# Access Compliance Report

## Public Rights-of-Way

### (Curb Ramps)

Intersection ID: 21535	Main Street: WOODSTOCK_DR	Cross Street: WOODSTREAM_DR	Location:	S
ADA ID: 67E8A97521D8	Ramp Type: PerpDiag	Initial Pass/Fail: Fail	Overall Compliance: No	Severity Score: 25

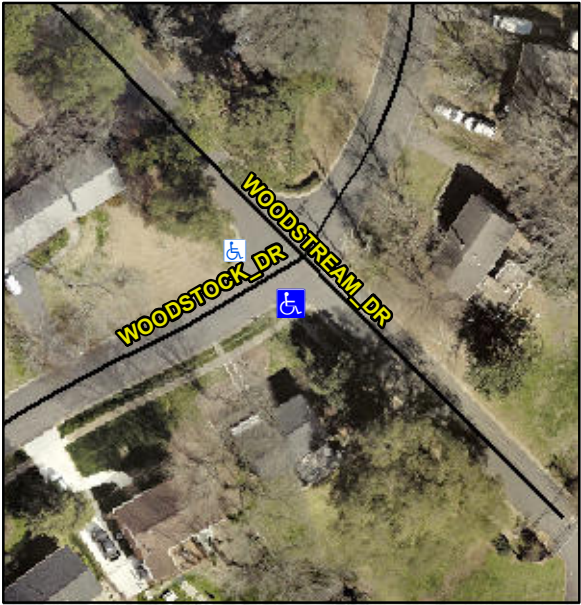
Codes/Mitigation Info/Possible Solution		Field Measurements/Component Compliance					
	Possible Solutions:	<b>Remove &amp; Replace Curb Ramp With Two New Directional Ramps or Equivalent.</b>					
	Surveyor Notes:	<b>N/A</b>					
	PROW/ADA:	<b>Not Found, R304.5.3</b>					
	Street 1 Name	<b>WOODSTREAM DR</b>					
	Stop Condition-Street 2	<b>None</b>					
	Street 2 Name	<b>WOODSTOCK DR</b>					
	Stop Condition-Street 1	<b>StopSign</b>					
	Total Cost:	<b>\$ 3200.00</b>					
				<b>Compliance</b>	<b>Description</b>	<b>Data</b>	<b>Compliance</b>
				<b>Description</b>			<b>Description</b>
				<b>Data</b>			<b>Data</b>
				<b>Yes</b>	<b>Ramp Length (in)</b>	<b>69.0</b>	<b>Yes</b>
				<b>No</b>	<b>Ramp Width (in)</b>	<b>48.0</b>	<b>No</b>
				<b>N/A</b>	<b>Flare Type LT</b>	<b>N/A</b>	<b>N/A</b>
				<b>N/A</b>	<b>Flare Slope LT (%)</b>	<b>N/A</b>	<b>N/A</b>
				<b>N/A</b>	<b>Flare Traversable LT?</b>	<b>N/A</b>	<b>N/A</b>
